STRUCTURAL REPORT Change of Use Suitability

Project: Hesselink Accessory Dwelling Conversion Project No.: TE-02207-25

Address: 2026 Reidsville Road, Ayr

LINTEL SCHEDULE

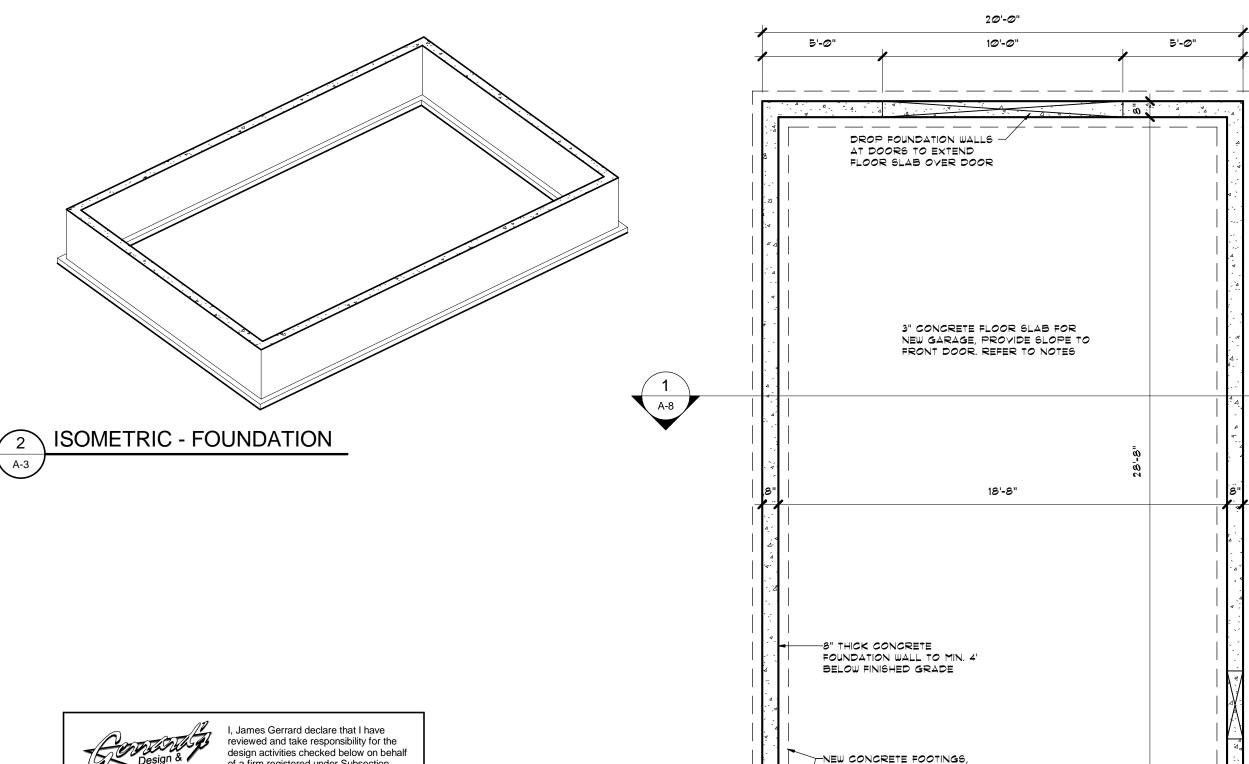
As per the "Lintel Schedule" included on drawing A-2, the design was carried out using a ground snow load of 1.5 kPa. This correlates to a max Ss value of 2.0 when using part 9 design (Cb = 0.55). Ss values of nearby surrounding towns and cities are as follows:

- Cambridge, Ss = 1.6 kPa (11 km away from subject property)
- Paris, Ss = 1.4 kPa (15 km away from subject property)
- Platsville, Ss = 1.9 kPa (15 km away from subject property)
- Kitchener, Ss = 2.0 kPa (15 km away from subject property)

Based on our review, we have determined that the original structural design of the accessory building appears to have been completed to be in compliance with Part 9 of the Ontario Building Code in place in 2017.
